Amendment to the Drawings:

## REMARKS

Fig. 4A

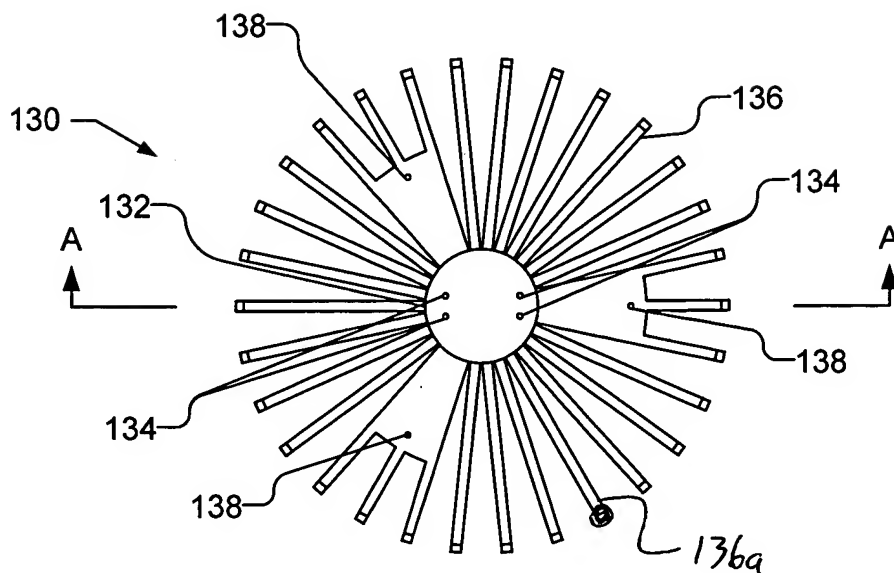
The attached sheet of drawings includes changes to Fig. 4A. This sheet, which includes Figs. 4A, 4B, and 4C, replaces the original sheet including Figs. 4A, 4B, and 4C. An annotated sheet of drawings is also attached illustrating the changes made.

The drawings were objected to as not showing every feature of the invention specified in the claims. Fig. 4A has been amended to illustrate a heat pipe. A replacement sheet and an annotated sheet illustrating the change is attached hereto. Reconsideration and withdrawal of the present objection is requested.

The specification has been amended to correct reference numbers and to provide a reference number for the heat pipe illustrated in amended Fig. 4A.
